Project	IEEE 802.16 Broadband Wireless Access Working Group < <a href="http://ieee802.org/16">http://ieee802.org/16</a> >
Title	New 802.16e Privacy Capability
Date Submitted	2004-11-04
Source(s)	Mo-Han Fong, Bill Gage, Haixiang He mailto:mhfong@nortelnetworks.com
Re:	IEEE 802.16e Privacy Sublayer
Abstract	Define a new privacy capability to enable rapid MAC signalling in a mobile environment, to reduce overhead and to support multiple network architectures. With this new capability, MAC subheaders are not encrypted and encryption is performed on a MAC SDU rather than on a MAC PDU.
Purpose	Review and adopt the suggested additions into P802.16e/D6.
Notice	This document has been prepared to assist IEEE 802.16. It is offered as a basis for discussion and is not binding on the contributing individual(s) or organization(s). The material in this document is subject to change in form and content after further study. The contributor(s) reserve(s) the right to add, amend or withdraw material contained herein.

Figure 1 : Encrypted MAC Frame in [1]

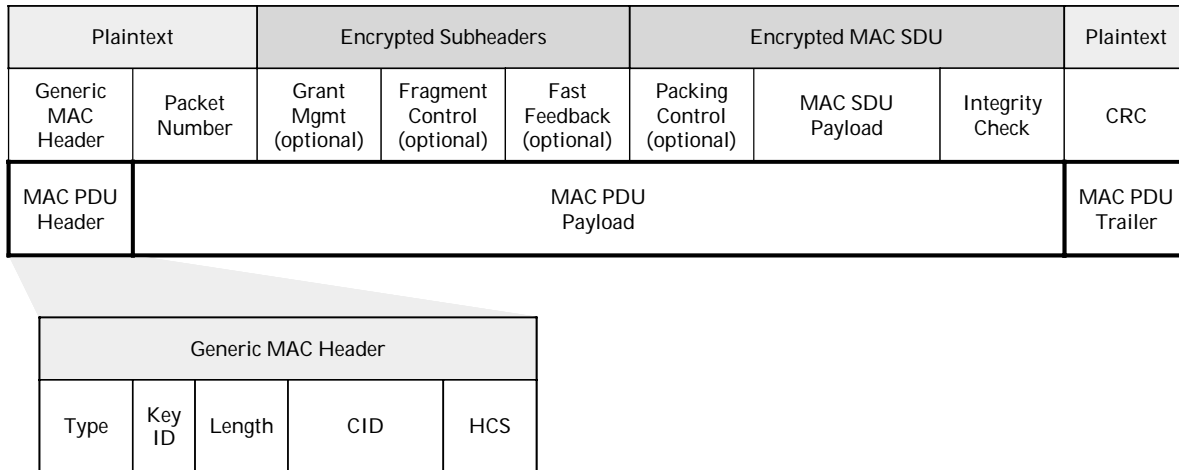
Figure 24 of [1] “Construction of a MAC PDU” indicates that encryption is the last operation performed before addition of the Generic MAC Header to a frame. As a consequence, all of the optional MAC PDU subheaders (grant management, fragmentation control, fast feedback, mode selection feedback) and the packing SDU subheaders are deemed to be part of the MAC PDU payload and are encrypted if security is enabled on a transport CID<sup>1</sup>. This is illustrated in Figure 1.

- *Increased delays in MAC layer scheduling.* Processing of grant and fast feedback subheaders must occur after decryption of the MAC PDU. The delay incurred in encrypting the frame at the transmitter and decrypting the frame at the receiver negatively impacts the responsiveness of the system.

- *Increased delays for ARQ-enabled connections.* Processing of fragmentation subheaders must occur after decryption of the MAC PDU. The delay incurred in decrypting the frame at the receiver negatively impacts the responsiveness of the system.

- *Increased overhead for fragmented packets.* Each fragment is encrypted separately and has its own packet number and integrity check value (ICV) added to the fragment.

4 **Figure 19a – MAC PDU Format**

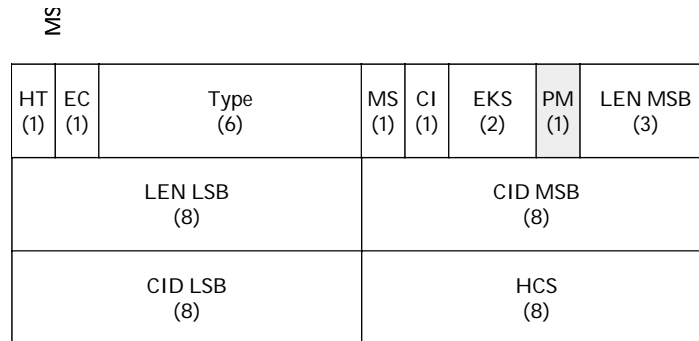
1 *[Modify Figure 19a as indicated:]*

Name	Length (bits)	Description
CI	1	CRC Indicator
CID	16	Connection Identifier
EC	1	Encryption Control
EKS	2	Encryption Key Sequence
HCS	8	Header Check Sequence
HT	1	Header Type
LEN	11	Length
MS	1	Mode Selection Feedback
<u>PM</u>	<u>1</u>	<u>Privacy Mode</u> <u>0 = PDU payload and subheaders encrypted</u> <u>1 = SDU encrypted</u>
Type	6

**Figure 24a – Construction of a MAC PDU (PM = 1)**

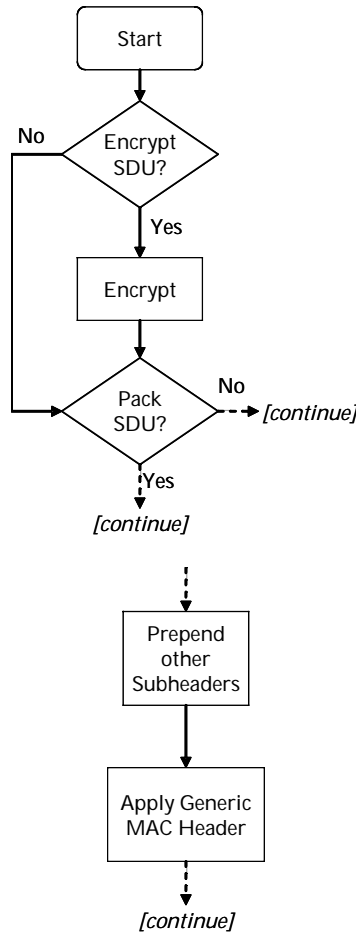
13 The construction of a MAC PDU when Privacy Mode is set to “0” is illustrated in Figure 24.  
14 The construction of a MAC PDU when Privacy Mode is set to “1” is illustrated in Figure  
15 24a.

17  
18 *[Add Figure 24a as follows:]*

**Figure 31a –MAC PDU Encryption**

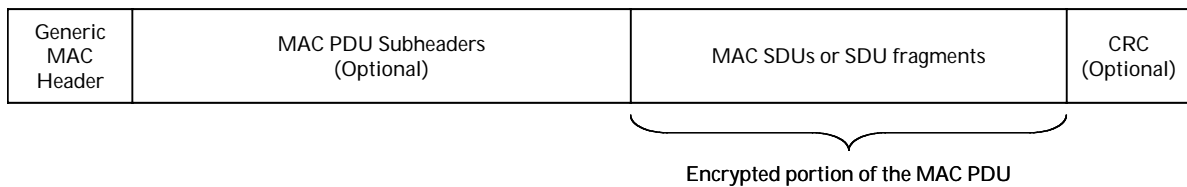
The generic MAC header shall not be encrypted. The Header contains all the Encryption information [EC Field, [privacy mode \(PM\) Field](#), encryption key sequence (EKS) Field, and CID] needed to decrypt a Payload at the receiving station. [If EC is set to “1” and PM is set to “0”, the entire MAC payload \(including MAC PDU subheaders\) is encrypted.](#) This is illustrated in Figure 31. [If EC is set to “1” and PM is set to “1”, the MAC SDUs and/or fragments thereof are encrypted but the MAC PDU subheaders are not encrypted. This is illustrated in Figure 31a.](#)

*[Add Figure 31a as follows:]*

**Figure 135a – TEK Management in BS and MSS (PM = 1)**

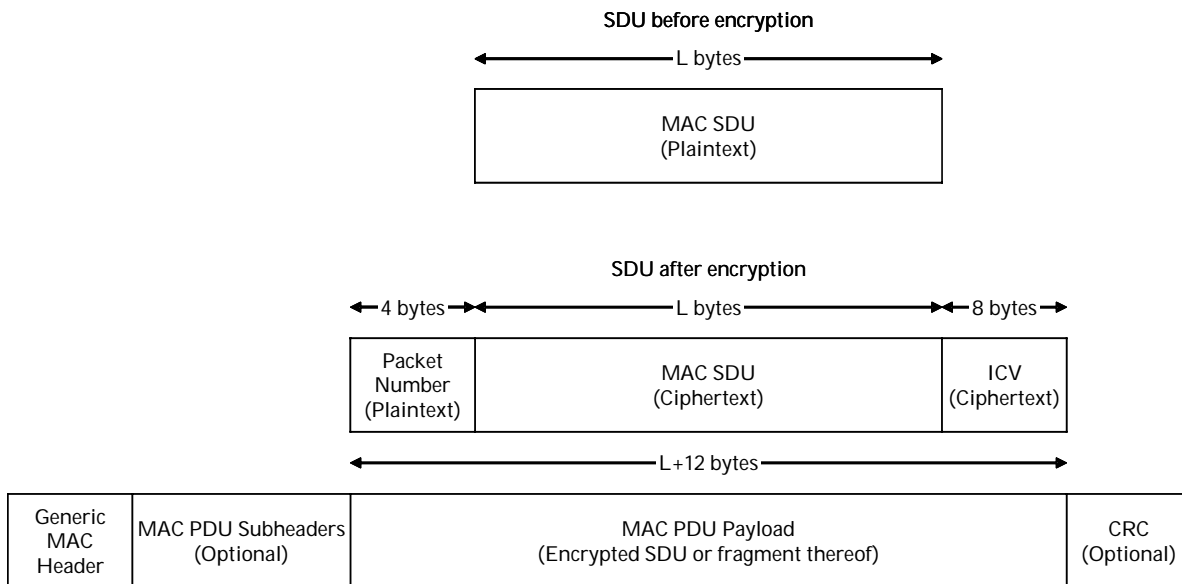
*[Add the following text and Figure 135a after Figure 135:]*

When Privacy Mode is set to “1”, the SDU shall be prepended with a 4-byte PN (Packet Number). The PN shall be transmitted in little endian byte order. The PN shall not be encrypted.

The plaintext SDU shall be encrypted and authenticated using the active TEK, according to the CCM specification. This includes appending an 8-byte ICV (Integrity Check Value) to the end of the SDU and encrypting both the plaintext SDU and the appended ICV. The ciphertext ICV is transmitted in little endian byte order. The processing yields an encrypted SDU that is 12 bytes longer than the plaintext SDU. The encrypted SDU may then be fragmented or packed as necessary to fit into a MAC PDU payload. This is illustrated in Figure 135a.
